## **2.2 Control and Instrument Systems**

The information in this section of the reference ABWR DCD, including all subsections, tables, and figures, is incorporated by reference with the following departures.

Figure 2.2.1 Rod Control and Information System Control Interface Diagram

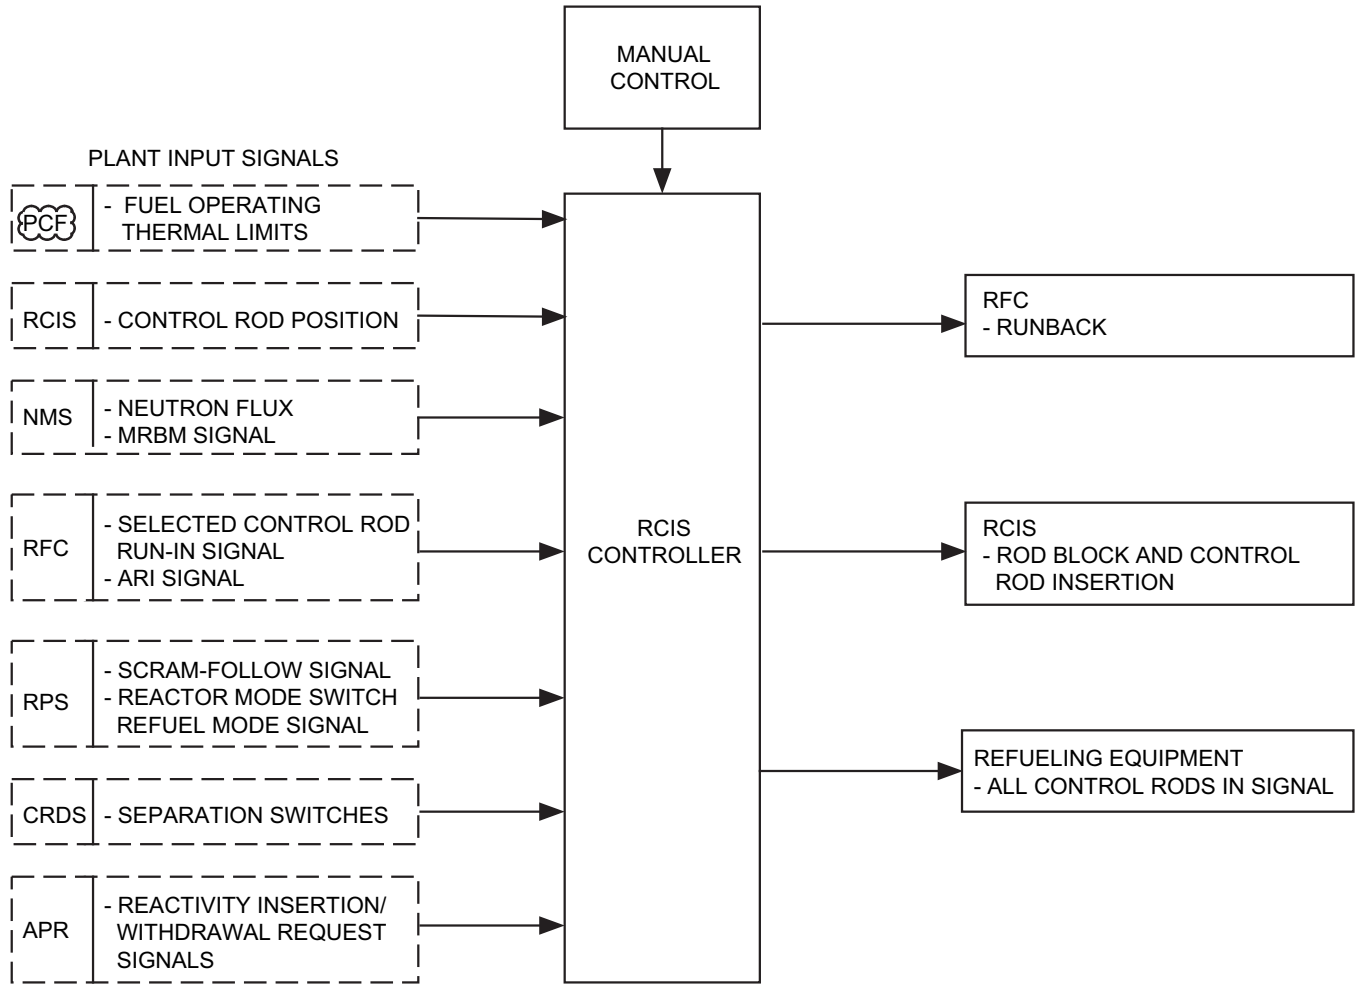
STD DEP T1 3.4-1 (Figure 2.2.1)

NOTE:  
1. INTERCONNECTIONS MAY BE FIBER-OPTIC OR METALLIC.

Figure 2.2.5 Neutron Monitoring System

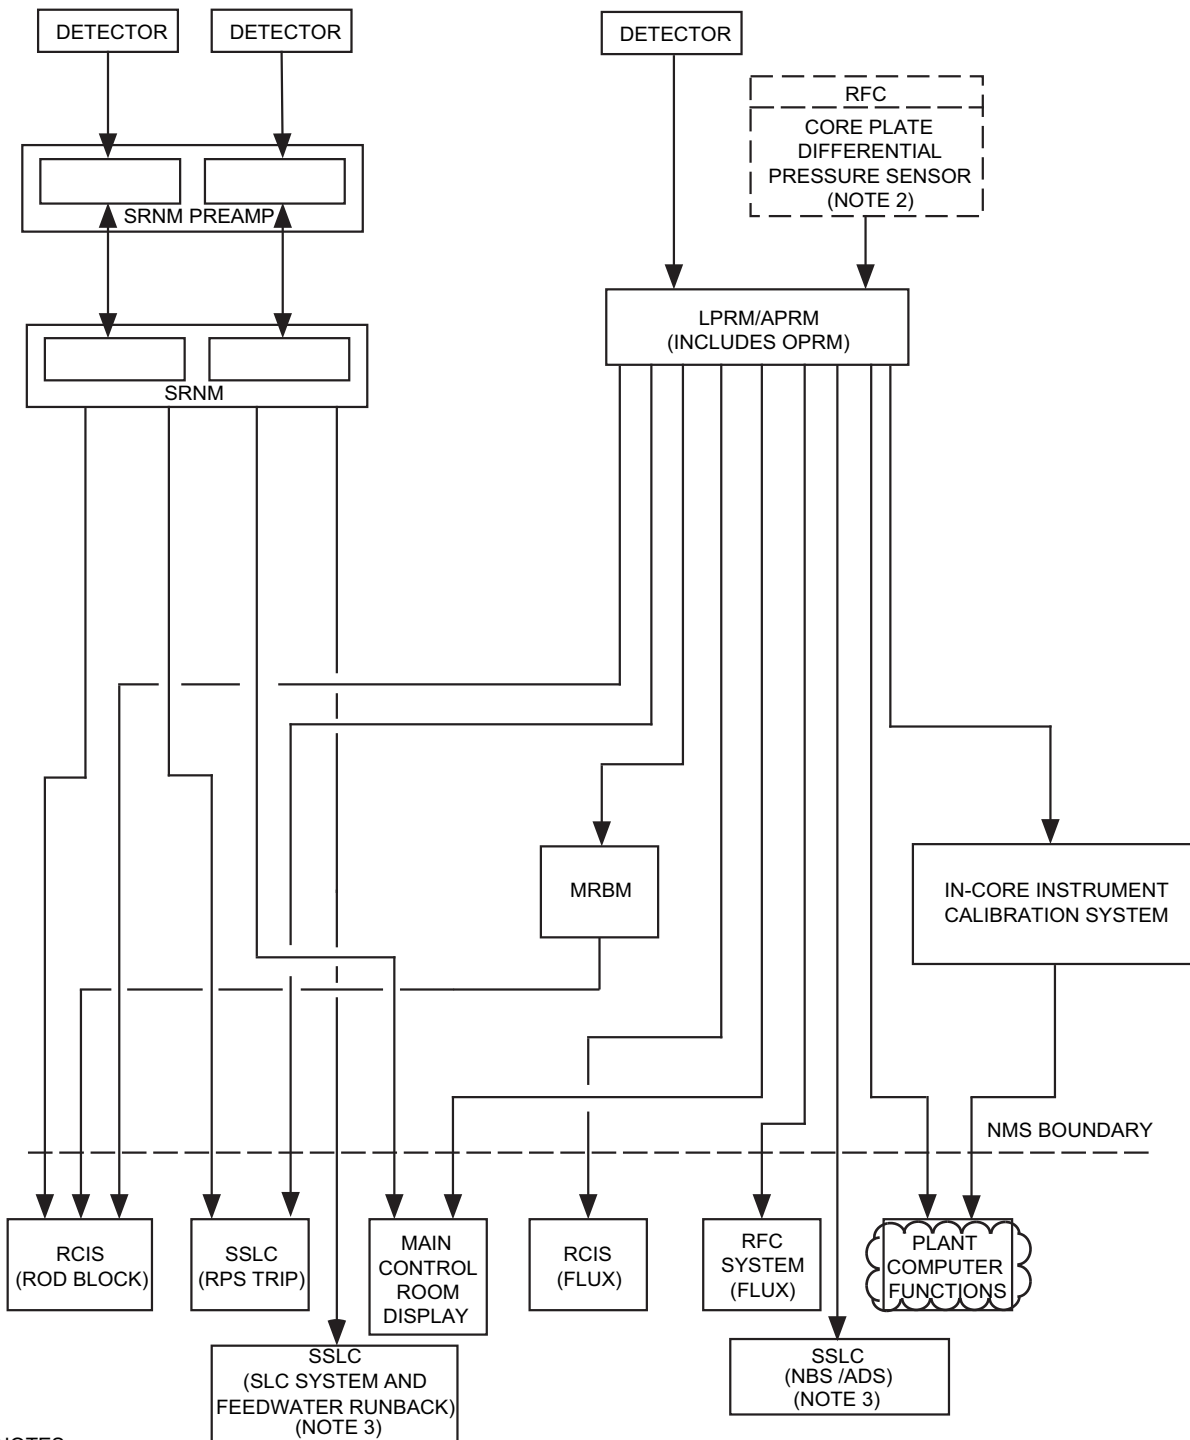
STD DEP T1 3.4-1 (Figure 2.2.5)

*The automated in-core instrument calibration system provides local power information at various core locations that correspond to LPRM locations. The automated in-core instrument calibration system uses its own set of in-core detectors for local power measurement and provides local power information for three-dimension core power determination and for the calibration of the LPRMs. The measured data are sent to the ~~Process Computer System~~ Plant Computer Functions for such calculation and LPRM calibration.*

Figure 2.2.6 Remote Shutdown System

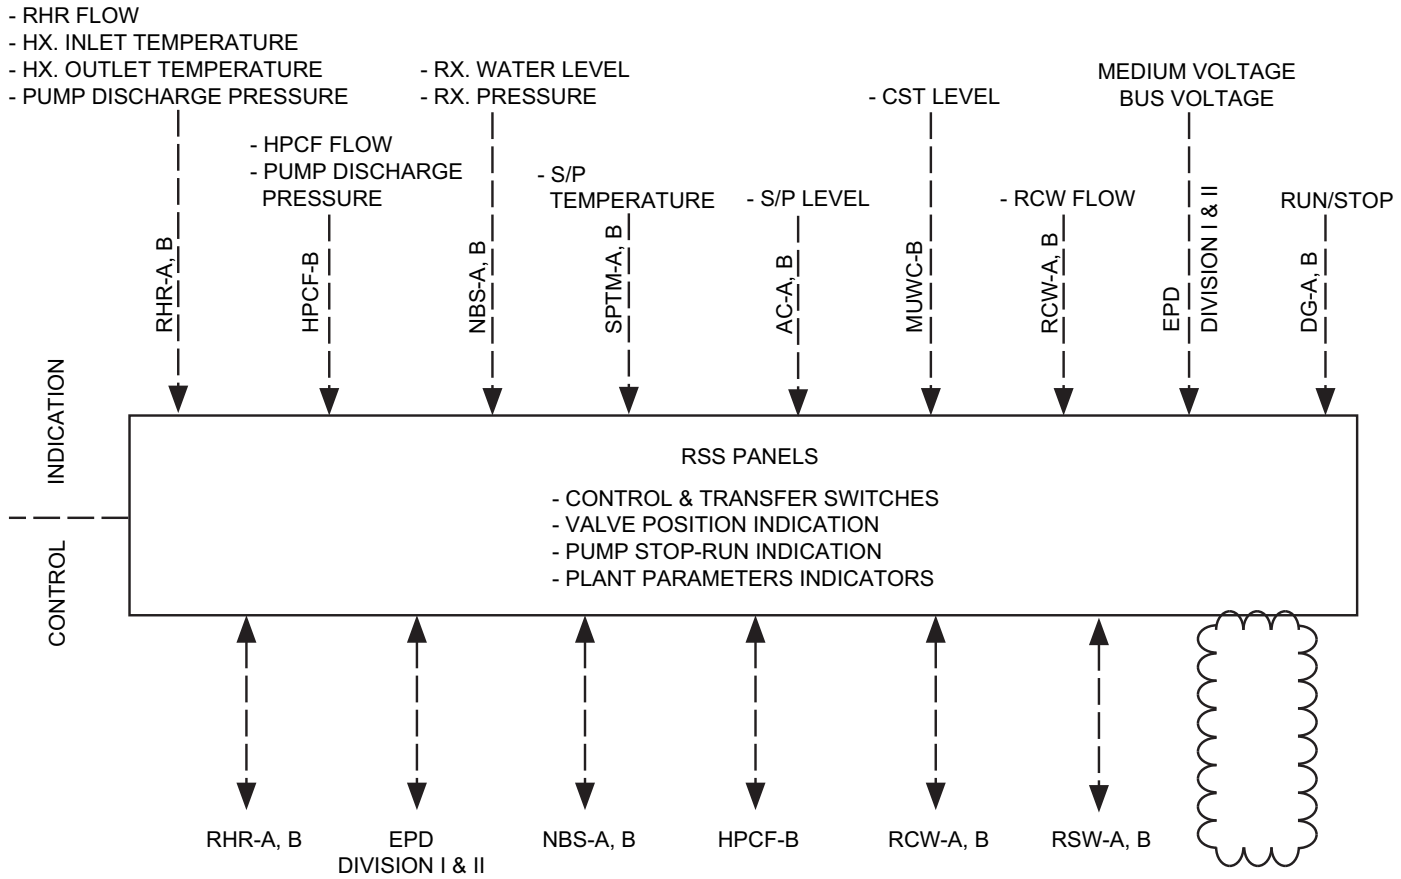
STD DEP T1 2.14-1 (Figure 2.2.6)

- (10) ~~Flammability Control System (FCS)~~ Not used

Figure 2.2.7b Reactor Protection System

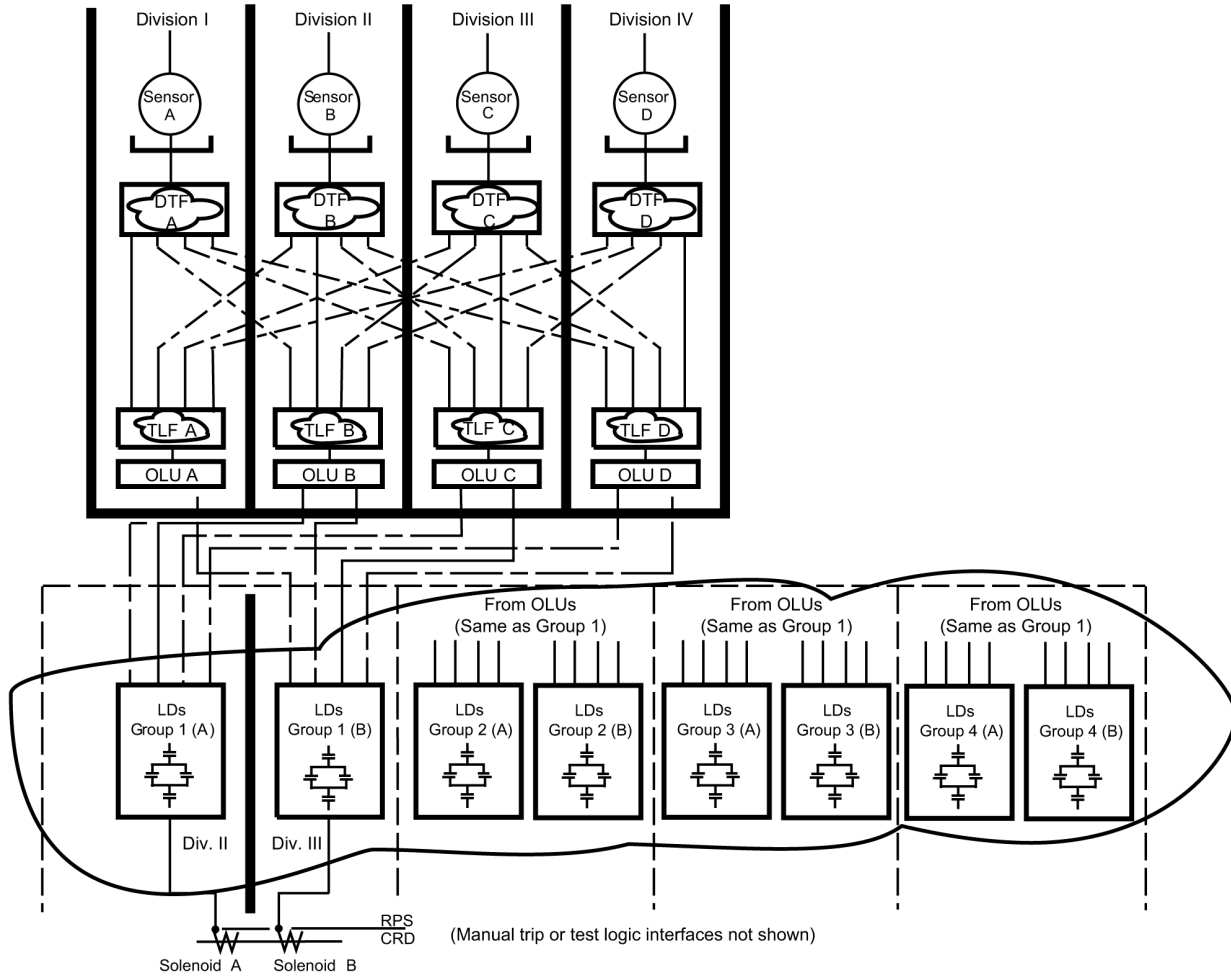
STD DEP T1 3.4-1 (Figure 2.2.7b)

The RPS has four divisions. Figure ~~2.2.6a~~ 2.2.7b shows the RPS divisional aspects and the signal flow paths from sensors to scram pilot valve solenoids. Functions Equipment within an RPS division consists of include sensors (transducers or switches), I/O, ~~multiplexers,~~ data communication, digital trip ~~modules~~ functions (DTM DTF), trip logic unit function (TLU TLF), output logic unit (OLU), and load drivers (LD). The LDs are only in Divisions II and III. The (DTF) and (TLF) are performed in digital configurable logic devices. The data communication functions are described in Section 2.7.5.
